STD 03-06

Informal Joint Working Group of GRB and GRRF – 16/17 Nov 2009

Comments of ISO/TC31/WG6 on
informal document GRB-50-7.

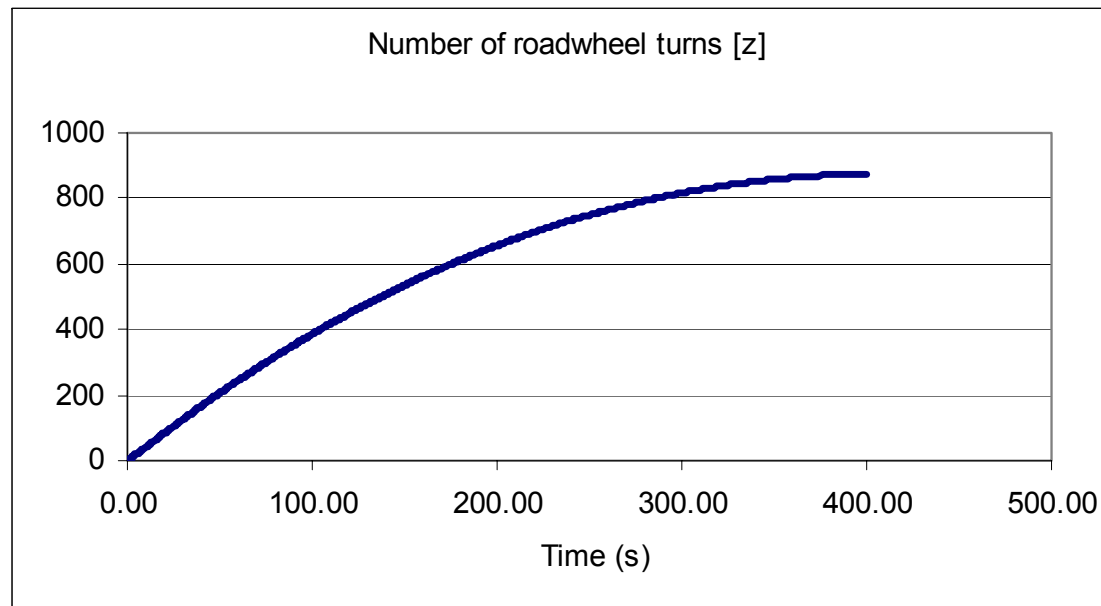
Second argument. Experimental evaluation of the proposed method.

- An example of deceleration obtained is shown below (tyre applied on the drum):

This measurement was done until t_{Σ} , total deceleration time, to check the result obtained.
